**STAFF RECOMMENDATION**

**1514 Ferguson Avenue**

**July 21, 2021**

**Application:** New Construction- Violation

**1st Floor Plan**  
 Scale: 1/4" = 1'-0"  
**1514 Ferguson Ave.**  
**Nashville, Tennessee**

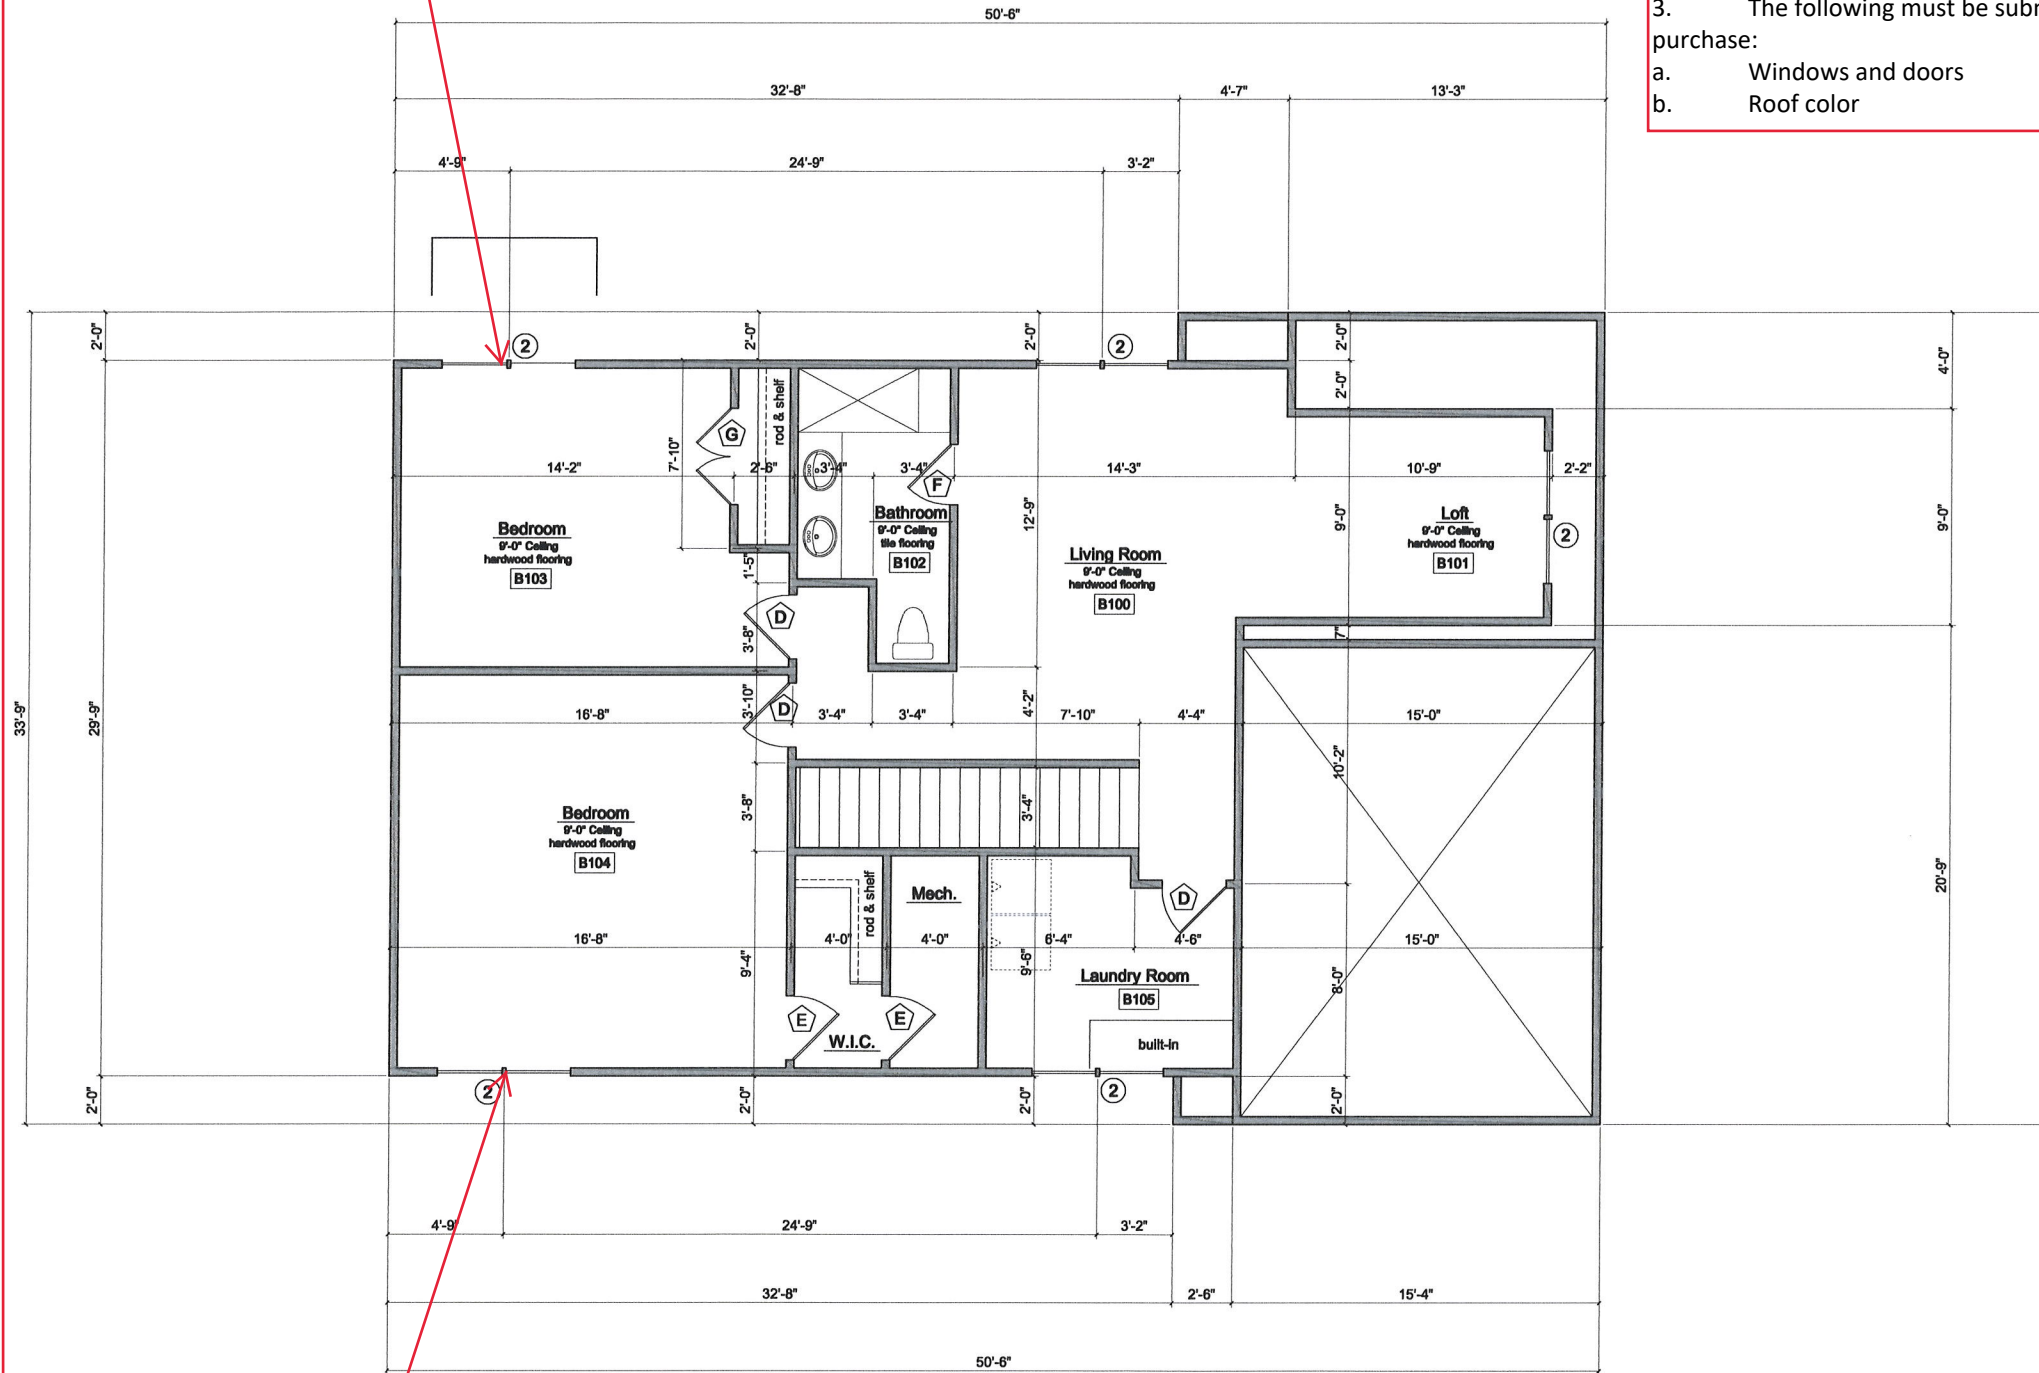
4-6" mullion required between the two windows

4-6" mullion required between the two windows

**2nd Floor Plan**  
 Scale: 1/4" = 1'-0"  
**1514 Ferguson Ave.**  
**Nashville, Tennessee**

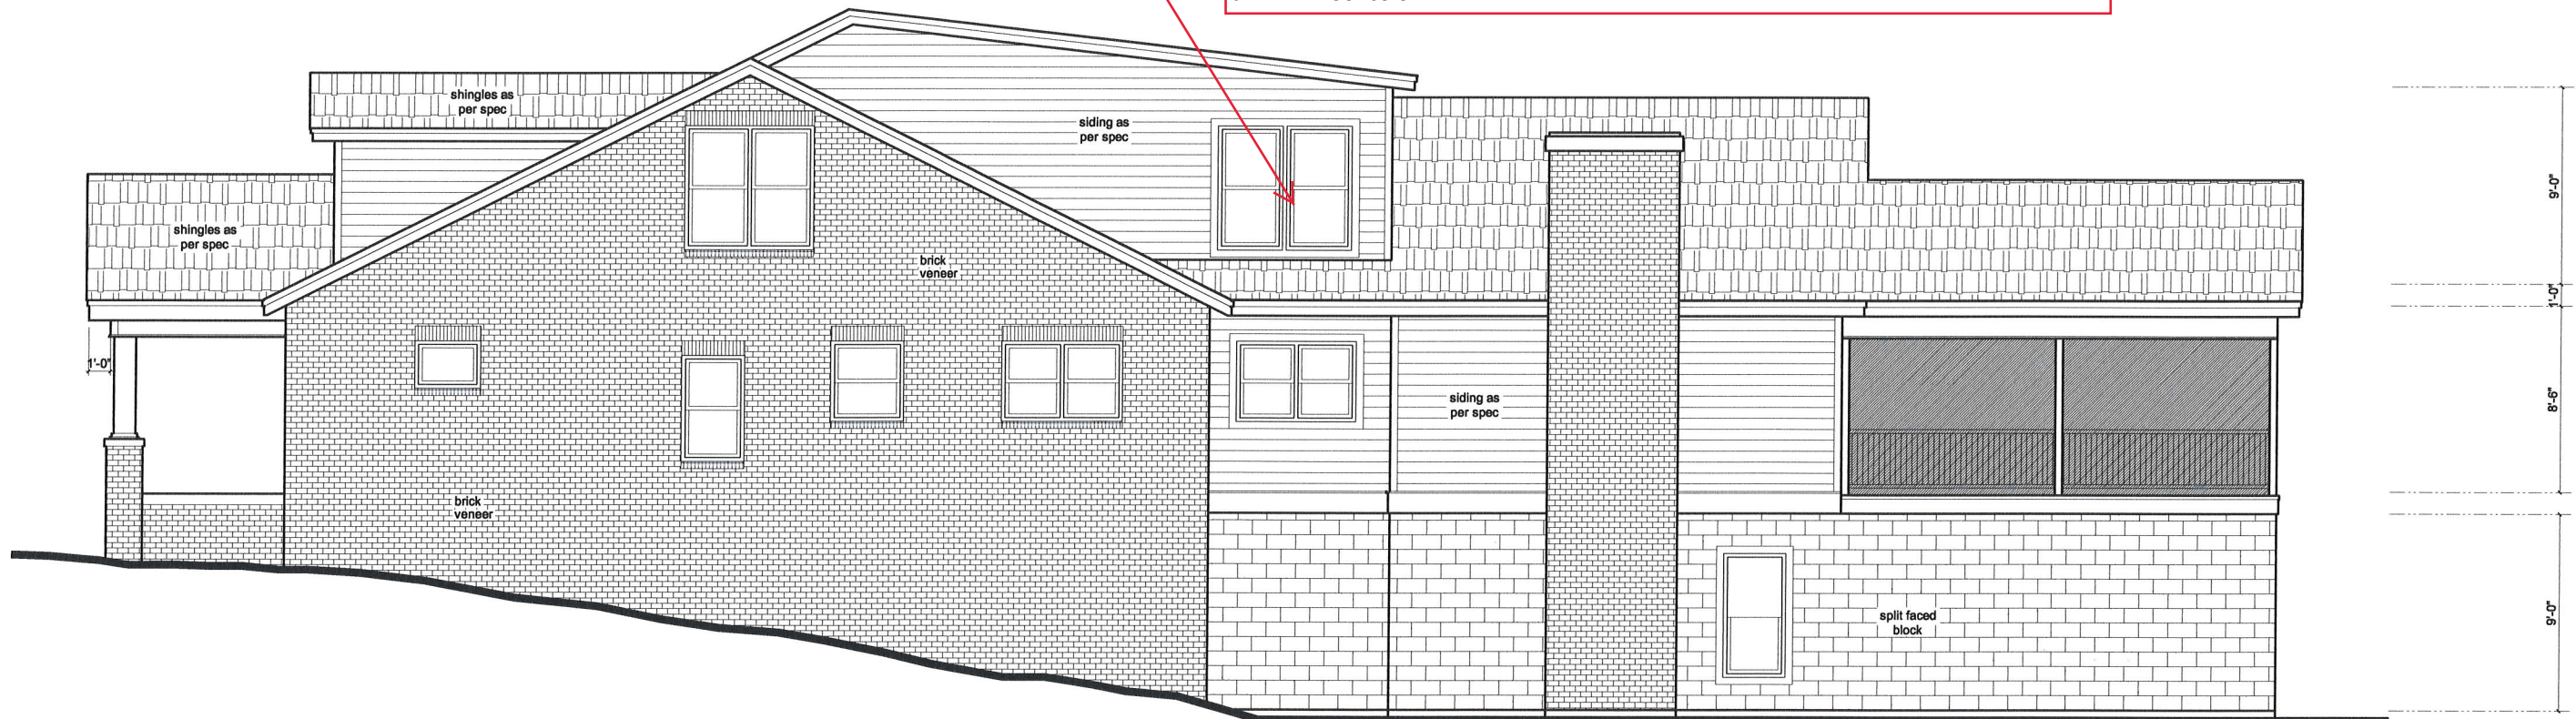
4-6" mullion  
required between  
the two windows

**Rear/Left Side Elevation**  
 Scale: 1/4" = 1'-0"

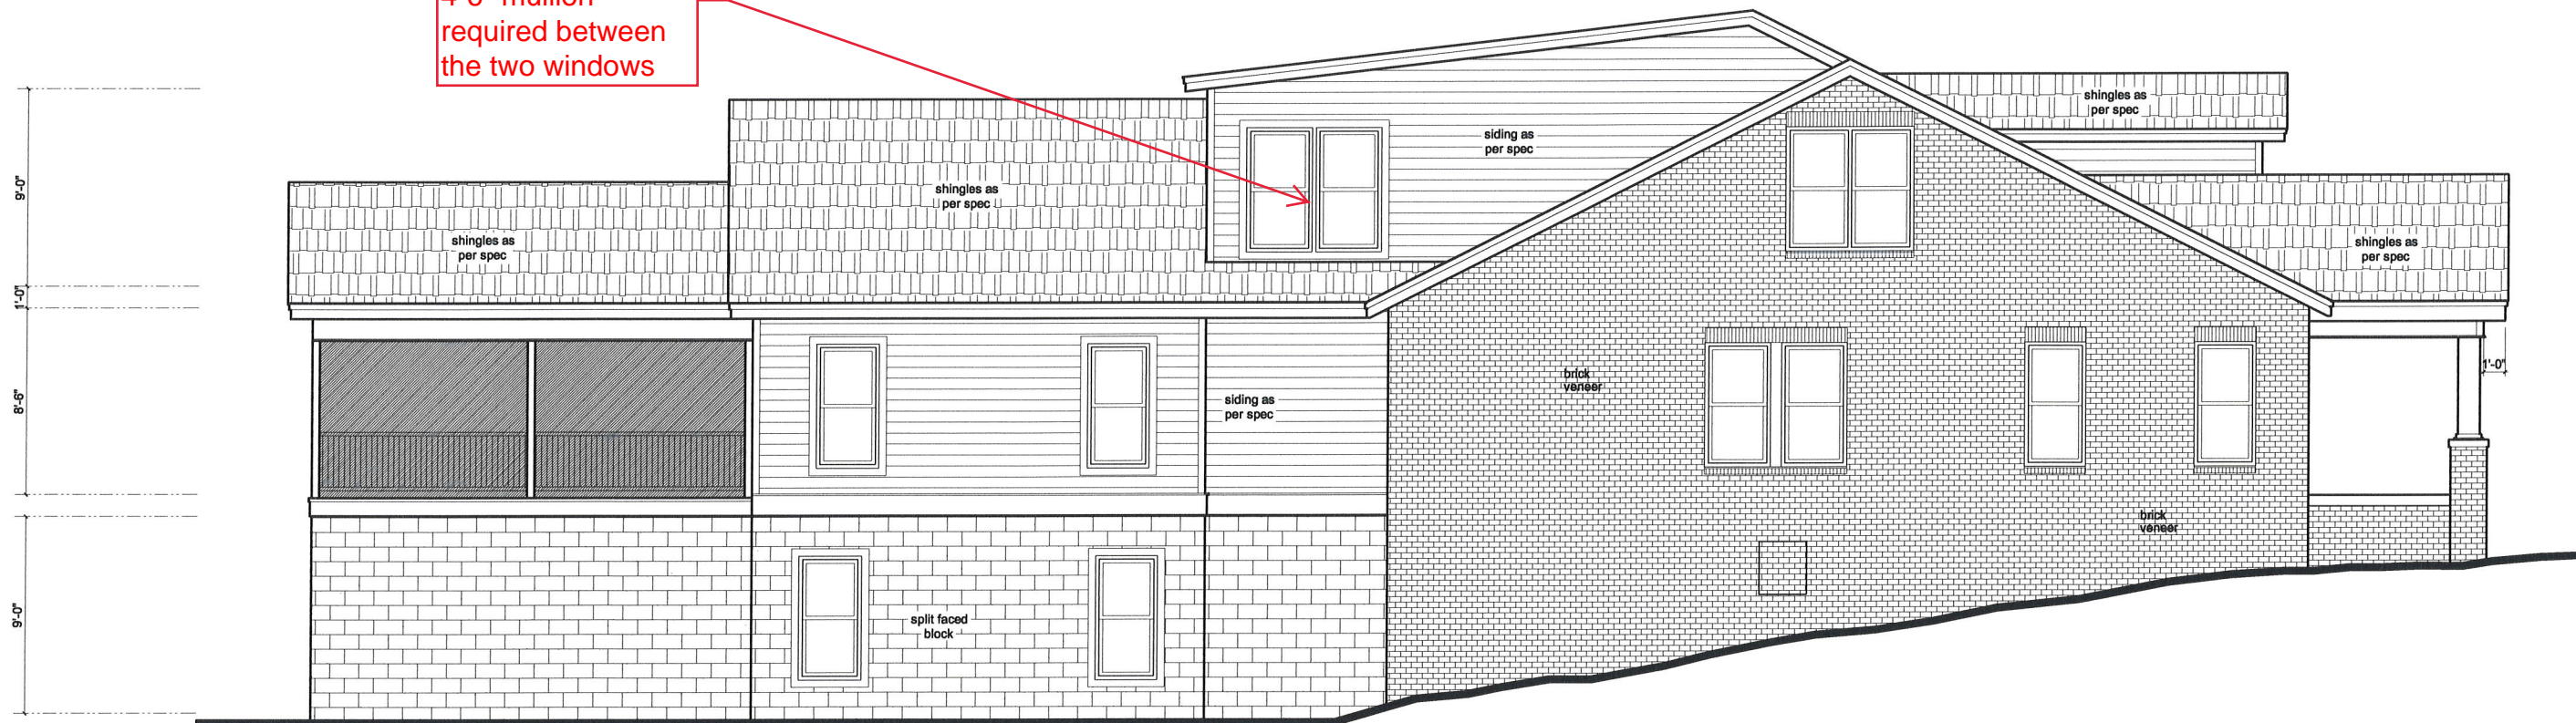
4-6" mullion required between the two windows
